Request	-	Special Use Permit for a new Community Center
Location	-	601 Junction Avenue
Applicant / Owner	-	Lucas County Land Bank One Government Center, Suite 580 Toledo, OH 43604
Engineer	-	Frederick Associates 4645 N. Summit Street Toledo, OH 43611

The staff recommends that the Toledo City Plan Commission recommend approval of SUP25-0022, a Special Use Permit for a new community center at 601 Junction Avenue, to the Toledo City Council, for the following three (3) reasons:

SPECIAL USE PERMIT  
TOLEDO CITY PLAN COMMISSION  
REF: SUP25-0022  
DATE: August 14, 2025  
TIME: 2:00 P.M.

# SITE PLAN B

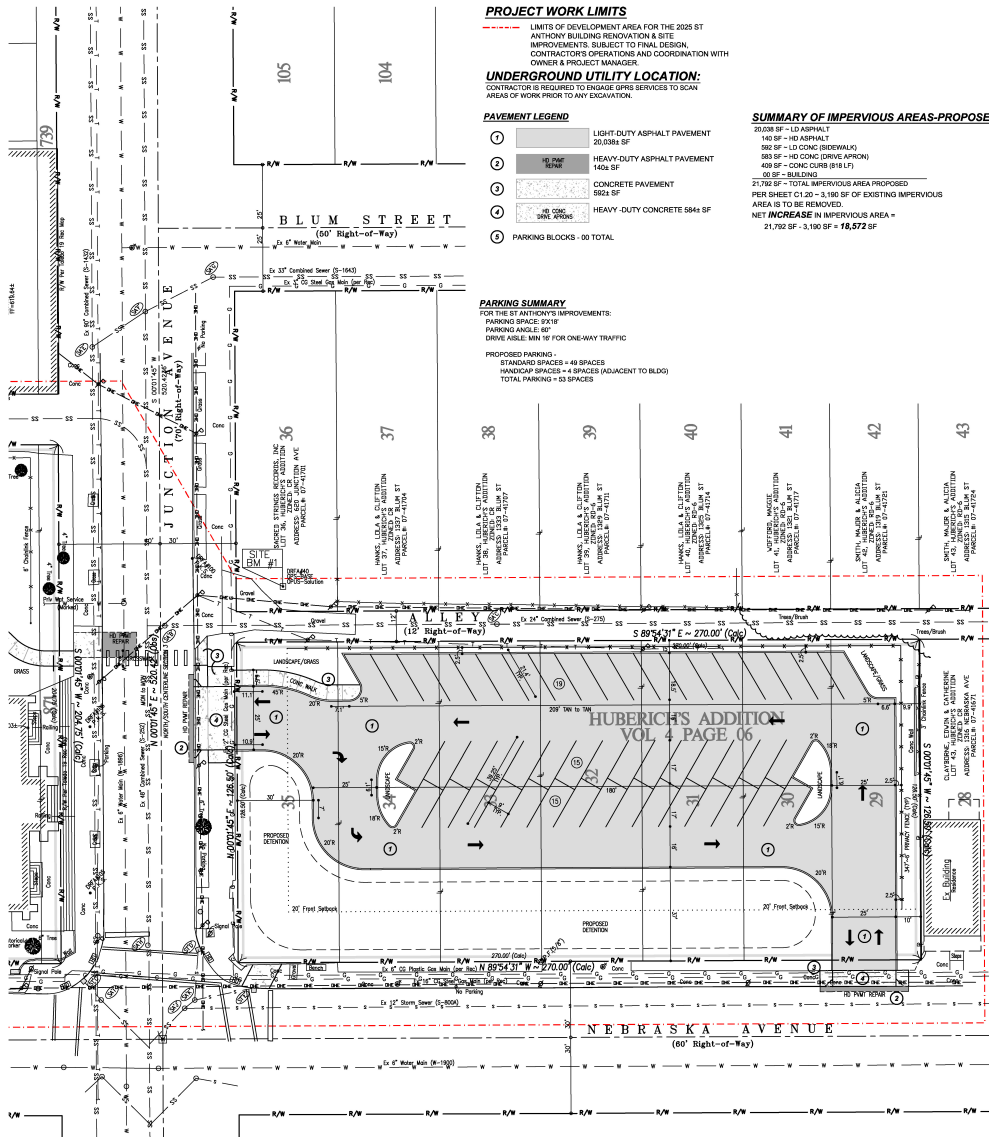
All auto accessible parking spaces must have a five foot (5') loading aisle per TMC§1107.1702(A). One (1) of the proposed accessible spaces is missing this loading aisle. The addition of this aisle on a revised site plan has been included as a condition of approval.

The Division of Traffic Management has objected to the proposed driveway access onto Junction Avenue and believes that effective parking lot access can be achieved solely off of Nebraska Avenue. Should access to Junction Avenue be desired, the applicant may be able to gain access via the existing alley – although they would have to improve the alley in order to do so. The removal of the proposed Junction Avenue driveway access has been included as a condition of approval. This condition goes on to permit the applicant to access the adjacent alley subject to review and approval by the Plan Director and Division of Traffic Management.

The Division of Traffic Management also objects to the proposed mid-block pedestrian crossing on Junction Avenue and asks that pedestrians be directed to the signalized crossing at the corner of Nebraska and Junction. Staff agrees that pedestrian utilization of this existing signalized crossing is preferred; however, there are concerns that the proposed detention area will naturally direct pedestrians away from this preferred crossing, leading to midblock crossings whether formalized or not. Ideally the detention area would be moved either underground or to the rear of the site; however, there would be significant cost in doing so as the site naturally drains towards the proposed detention area. Traffic Management's condition to remove the mid-block crossing has been included as a condition of approval.

6. All auto accessible parking spaces must have a 5' loading aisle per TMC 1107.1702 (A). (One auto accessible parking space does not have a loading aisle.)

7. Accessible parking signage must be posted directly in front of the parking space at a height of no less than 60 inches and no more than 72 inches above pavement level per TMC 1107.1704. (Accessible parking sign detail is too tall.)

8. All parking spaces, driveways and drive aisle must be clearly dimensioned on drawings per TMC 1107.1911. (Existing parking near new accessible parking is not dimensioned.)

9. Drive aisles are required to be 25' wide for two-way traffic per TMC 1107.1911.
10. Adjacent parking lot shall direct pedestrians to corner of Nebraska and Junction to promote utilizing signalized crossing. The mid-block crossing shall not be permitted for safety concerns of pedestrians.

11. Traffic Management will not permit Junction Avenue driveway access for the adjacent parking lot.
12. Any and all unused curb cuts and drive approaches must be removed on Junction Avenue and replaced with new curb and grass to match adjacent areas.

LANDSCAPE PLAN

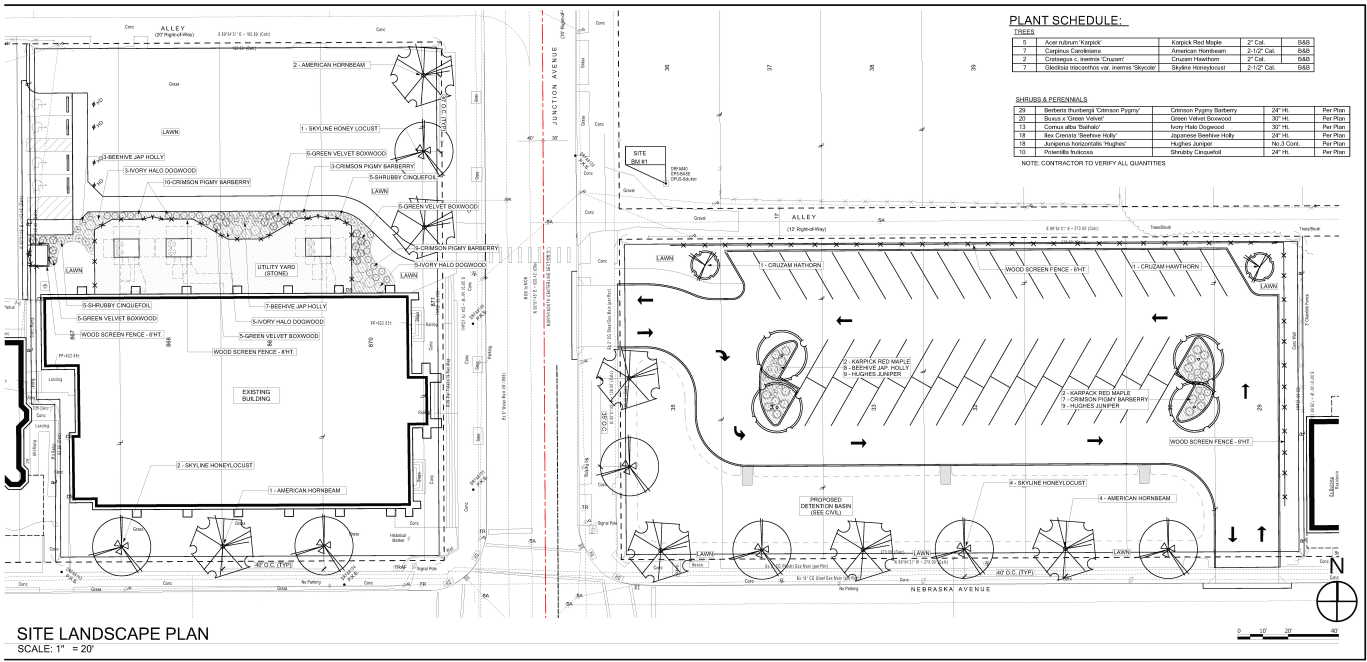
TMC§1108.0202 *Frontage Greenbelt* requires a fifteen foot (15') wide frontage greenbelt along both Junction Avenue and Nebraska Avenue. At least one (1) tree is required within these frontage greenbelts for every thirty feet (30') of frontage. Four (4) trees are required along Junction Avenue and nine (9) trees are required along Nebraska Avenue. The site plan depicts thirty-foot (30') wide frontage greenbelts with two (2) trees along Junction Avenue and six (6) trees along Nebraska Avenue. Five (5) additional trees are required within these frontage greenbelts. The addition of these required trees on a revised landscape plan has been included as a condition of approval.

TMC§1108.0202 *Frontage Greenbelt* also requires a solid evergreen hedge planting within the frontage greenbelts when abutting a parking lot. Low, undulating (horizontal and vertical) earth berms or decorative stone or brick walls (no concrete block), or ornamental metal fencing or combinations thereof may also be approved by the Planning Director. None of these options have been proposed; however, it is required in order to screen the parking lot. The addition of a frontage greenbelt screen – whether evergreen shrubs or another method approved by the Planning Director – on a revised landscape plan has been included as a condition of approval.

A Type A landscape buffer is required along the parking lot's eastern property line per TMC§1108.0203 due to the adjacent property's Duplex Residential (RD6) zoning classification. A ten foot (10') wide landscape area with a solid fence or wall with a minimum height of six feet (6') is required in this area. Four (4) trees and fifteen (15) shrubs are required for every 100 linear feet. As such, five (5) canopy trees and nineteen (19) shrubs are required within this eastern Type A buffer area. No trees or shrubs are shown on the landscaping plan within the provided ten foot (10') wide landscape buffer. The addition of these trees and shrubs on a revised landscape plan has been included as a condition of approval.

TMC§1108.0204 *Parking Lot Landscaping* requires two (2) canopy trees and six (6) shrubs for every ten (10) parking spaces within a parking lot. Ten (10) trees and thirty (30) shrubs are required in this forty-nine-space (49) parking lot. Six (6) trees and thirty-three (33) shrubs are shown on the landscaping plan. The addition of these required interior parking lot trees has been included as a condition of approval.

32. Pursuant to TMC§1108.0202 the frontage greenbelts along Junction and Nebraska Avenues adjacent to the proposed parking lot require least one (1) tree for every thirty feet (30') of frontage. **Not acceptable as depicted. A revised landscape plan shall be submitted to the Plan Director depicting at least four (4) trees within Junction Avenue greenbelt and nine (9) trees within Nebraska Avenue greenbelt.**

33. Pursuant to TMC§1108.0202 the frontage greenbelts along Junction and Nebraska Avenues adjacent to the proposed parking lot require a solid evergreen hedge planting. Low earth berms, decorative stone or brick walls, ornamental metal fencing, or combinations thereof may also be approved by the Planning Director. **Not acceptable as depicted. A revised landscape plan shall be submitted to the Plan Director depicting an acceptable screen within the Junction Avenue and Nebraska Avenue greenbelts.**

35. A Type A landscape buffer is required along the parking lot's eastern property line pursuant to TMC§1108.0203. Four (4) canopy trees and fifteen (15) shrubs are required for every 100 linear feet. **Not acceptable as depicted. A revised landscape plan shall be submitted to the Plan Director depicting at least five (5) canopy trees and nineteen (19) shrubs within this type A buffer.**

36. Two (2) canopy trees and six (6) shrubs are required for every ten (10) parking spaces within the parking lot pursuant to TMC§1108.0204. **Not acceptable as depicted. A revised landscape plan shall be submitted to the Plan Director depicting at least ten (10) trees and thirty (30) shrubs within or adjacent to the parking lot.**

# PARKING LOT GRADING PLAN

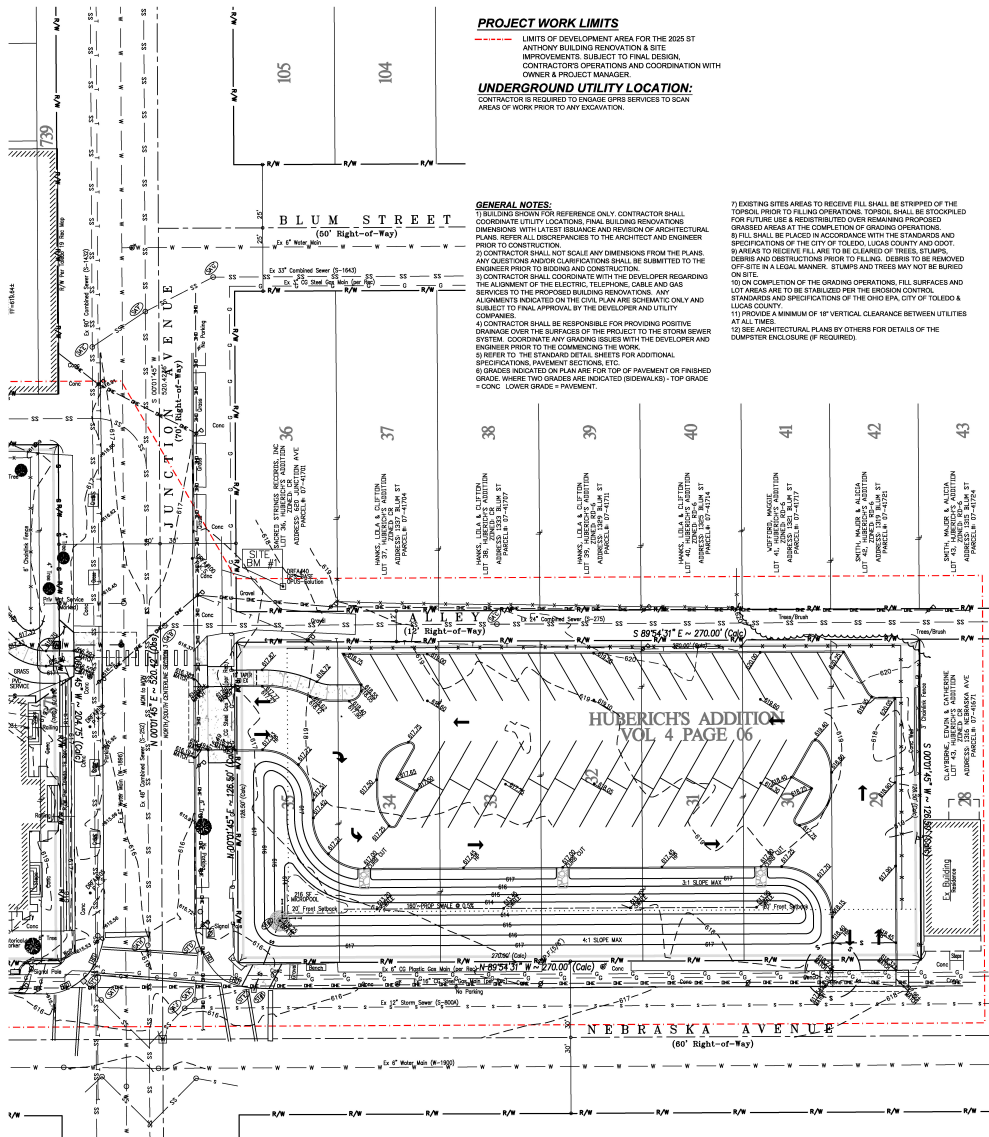
Lastly, TMC§1108.0202 *Frontage Greenbelt* prohibits traditional retention and detention pond stormwater treatment facilities within the required frontage greenbelt. Other stormwater treatment facilities may occupy only up to fifty percent (50%) of the frontage greenbelt. A swale stormwater treatment facility is proposed in the majority of the frontage greenbelt. A small portion of the facility – the area labeled “micropool” on the attached parking lot grading plan – is considered a traditional retention/detention pond. TMC§1108.0202 permits the Plan Director to waive these requirements if, in consultation with the City of Toledo's Division of Engineering Services, it is determined that physical site characteristics or constraints cause placement of these facilities elsewhere impractical. The Plan Director is willing to waive this requirement in this fashion so long as a portion of the stormwater facility is planted as a low maintenance pollinator garden. The submission of low maintenance pollinator garden details to the Plan Director for review and approval has been included as a condition of approval.

18. Designer should consider potential for sewer gas odor at proposed new downspout connections.
19. Basin footprint and size will need confirmed to provide for the required flow restriction, flood control volume, and side slope grading.

34. Portions of the proposed stormwater treatment facility shall be planted with a low maintenance pollinator garden. Low maintenance pollinator garden details shall be submitted to the Plan Director for review and approval.
